COMMUNITY BOARD FEEDBACK PACKAGE

Business Name: Taqueria Condesa

Cafe Address: 824 9th Avenue, New York, NY, 10019

Application Number: 20260401010002

Sidewalk Cafe Site Plan Form

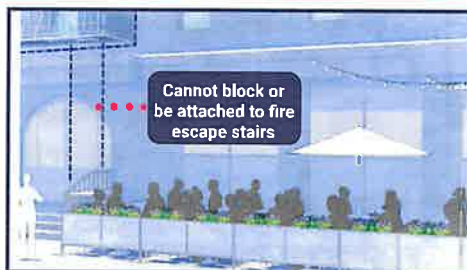
The proposed sidewalk cafe Site Plan does not allow the required clear path between the traffic signal and the cafe perimeter on the 9th Avenue side of the cafe. To remedy this issue, the applicant has agreed to remove one table with 2 seats from the 9th Avenue corner of the cafe, as reflected on the attached Revised Site Plan.

The proposed sidewalk cafe Site Plan does not allow the required clear path between the traffic signal and the cafe perimeter on the 9th Avenue side of the cafe. To remedy this issue, the applicant has agreed to remove 1 table with 2 seats from the 9th Avenue corner of the cafe, as reflected on the attached Revised Site Plan.
